Federal Aviation Administration
Aviation Rulemaking Advisory Committee

Air Carrier Operations Issue Area
Noise Abatement Takeoff Profiles Working Group

Task 1 – Close In and Distant Standard Takeoff Profiles

Subject: Recommendation of the Air Carrier
Operations Subcommittee

**FAR 25.111C(3)
ENGINE OUT PERFORMANCE**

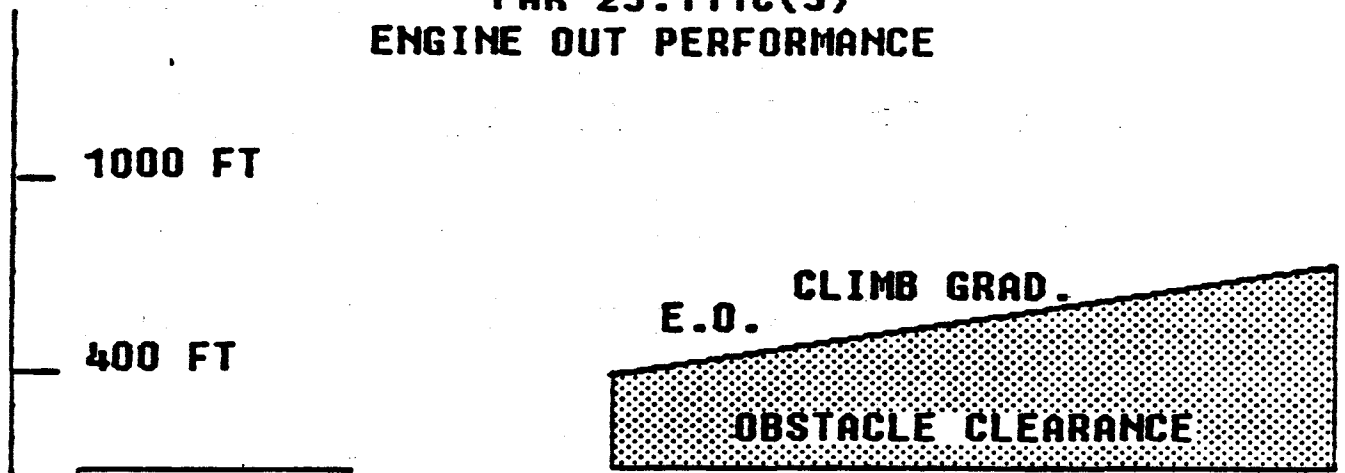
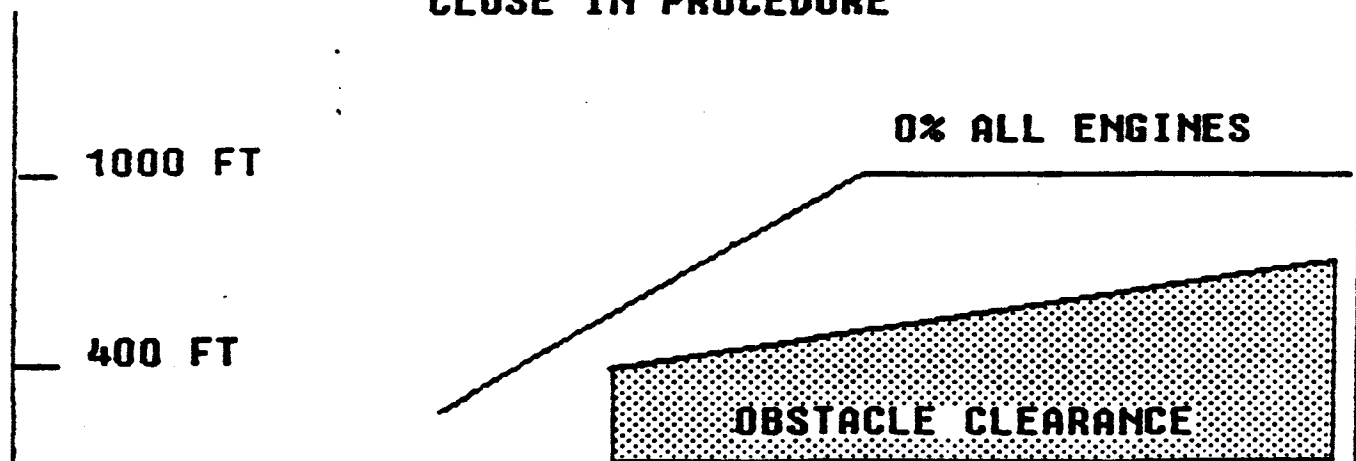
FAR 25.111c(3) specifies an engine out gradient starting at 400 ft. that provides an obstacle clearance path. (See Fig. (1)). Any close-in noise abatement takeoff with a cutback initiated above 400 ft. and the appropriate thrust restoration method can

maintain the aircraft at or above the FAR 25.111C(3) obstacle clearance path. (See Fig. (2)).
